Infrastructure NSW's Blackwattle Bay Response to Submissions

I write to you regarding Infrastructure NSW's (INSW) Blackwattle Bay Response to Submissions (RtS) currently open for comment.

To assist the project, the City completed a [Design Review](#) of the proposal which found the Blackwattle Bay proposal needed the following improvements:

Figure 61 Sun plane 03 for ground floor apartments within Site 03, shown individually (top) and combined (bottom)

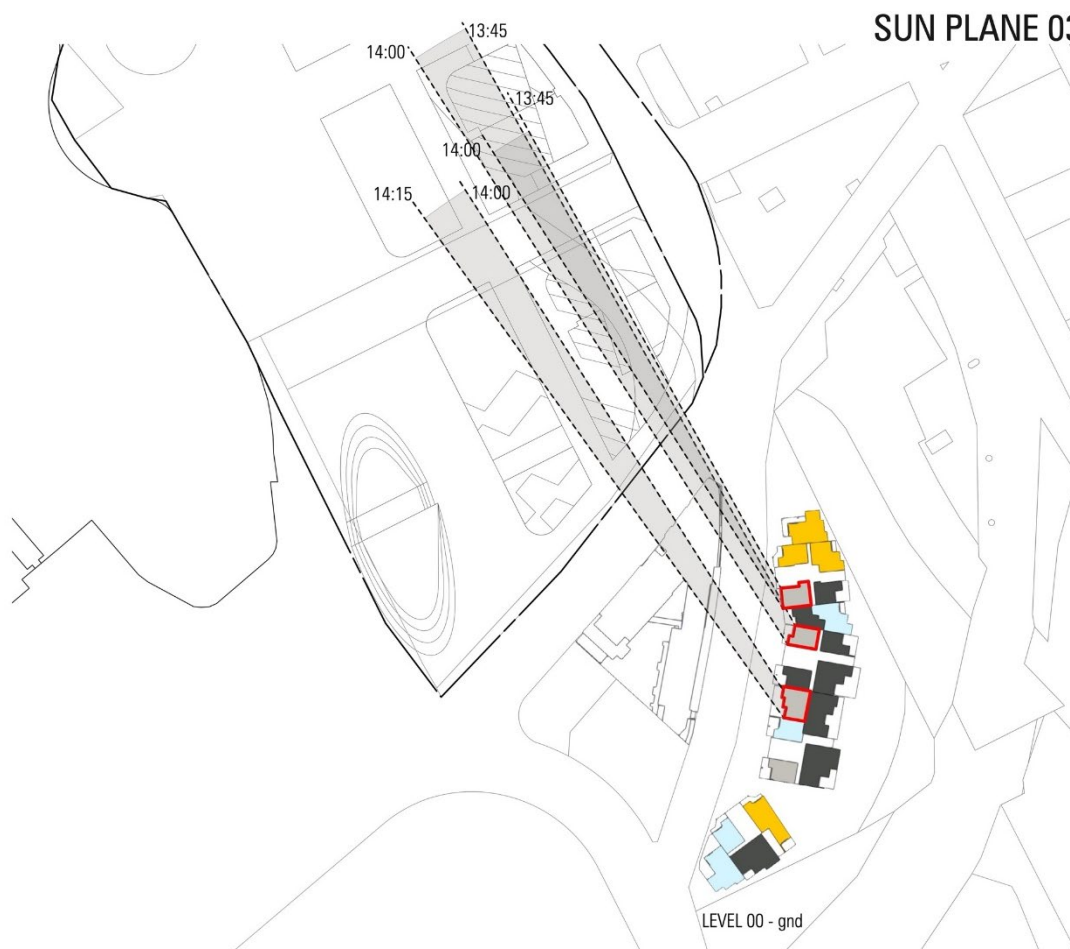
Figure 61 illustrates the addition of Sun Plane 03. This sun plane maintains solar access to an additional three ground level apartments with Site 03.

Figure 63 Sun plane 04 for an additional ground floor apartment within Site 03, shown individually (top) and combined (bottom)

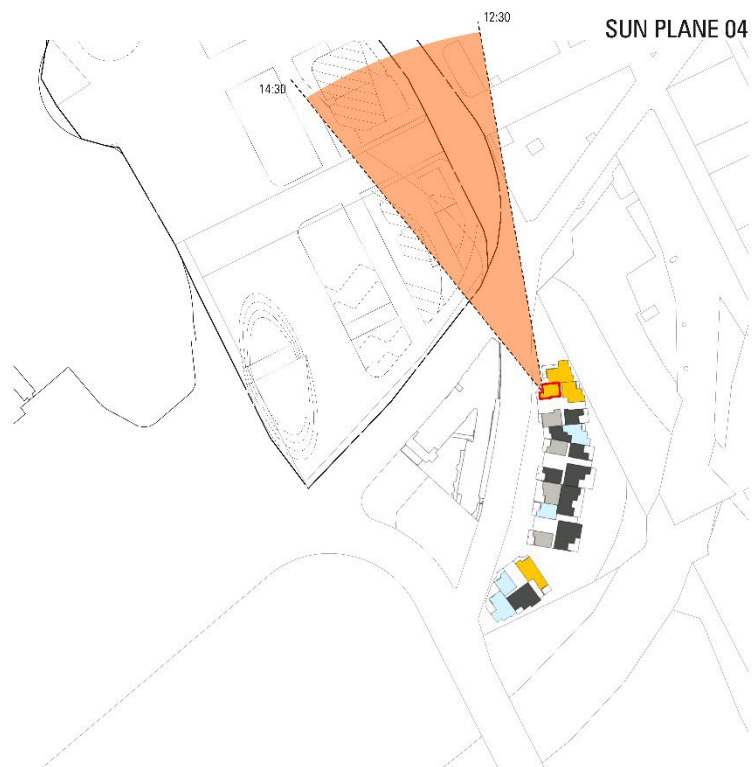
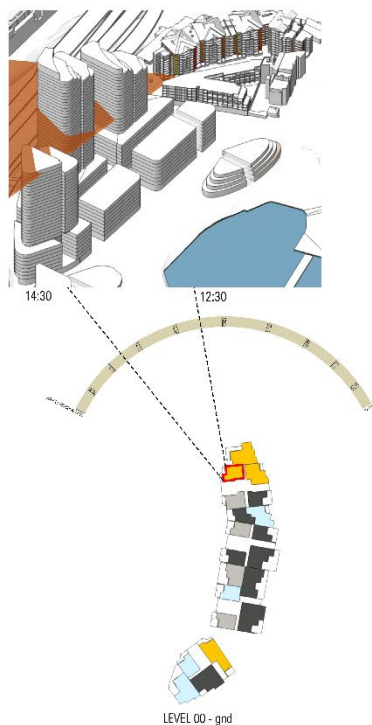
Figure 63, illustrates the addition of Sun Plane 04. This sun plane maintains solar access to an additional ground level apartment with Site 03.

Figure 66 Comparison of overshadowing of the Glebe foreshore, at 8:00 am and 8:30 am on the Winter Solstice

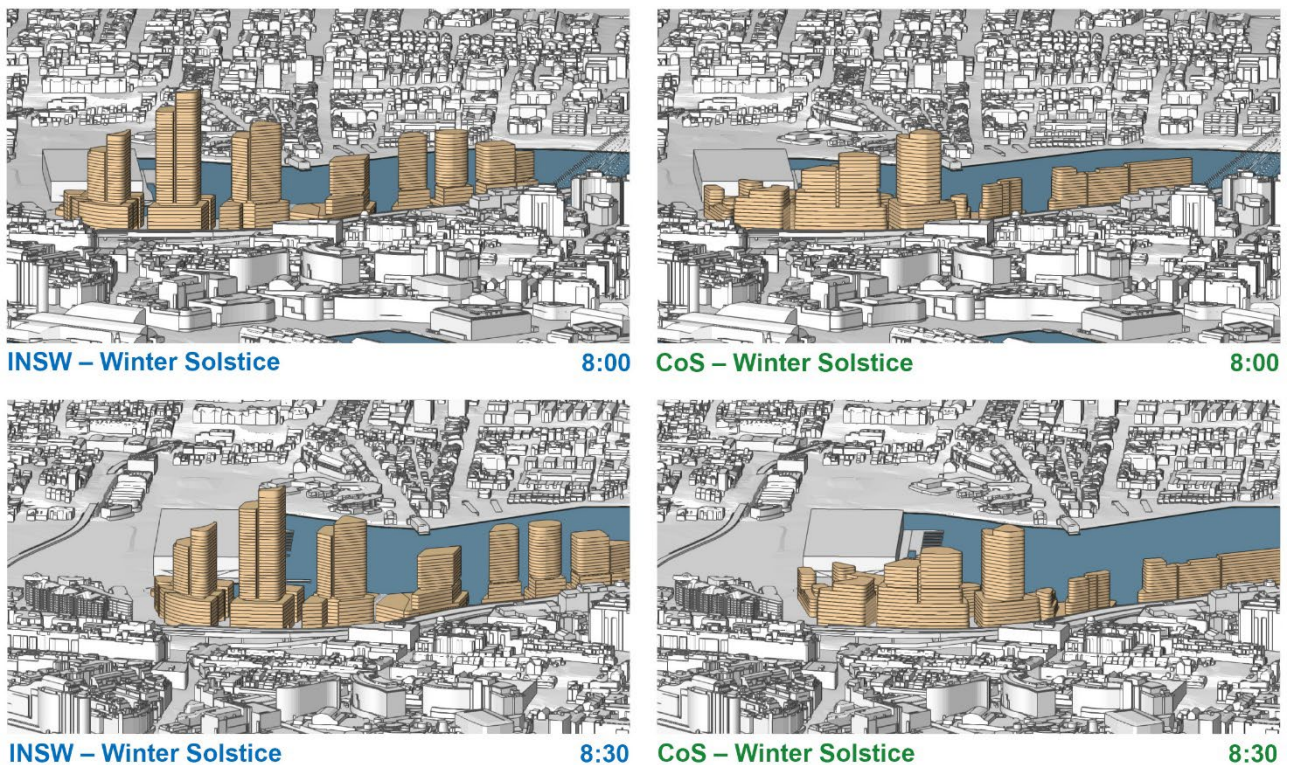
Overshadowing was a key issue raised by community during the exhibition. Concern was raised in relation to overshadowing of the Glebe foreshore and maintaining solar access to the new Sydney Fish Market rooftop solar panels. The Design review modelled the shadowing of the INSW study shown as views from the sun in Figure 66 below.

The low angle of the sun during the winter solstice and position of the site in relation to the new Sydney Fish Market result in overshadowing of the building's roof in the INSW study. As shown in Figure 66 and Figure 67, the overshadowing impacts continue into the morning as the sun swings around, with shadows from different buildings being cast over the Sydney Fish Market roof until after 10:00 am.
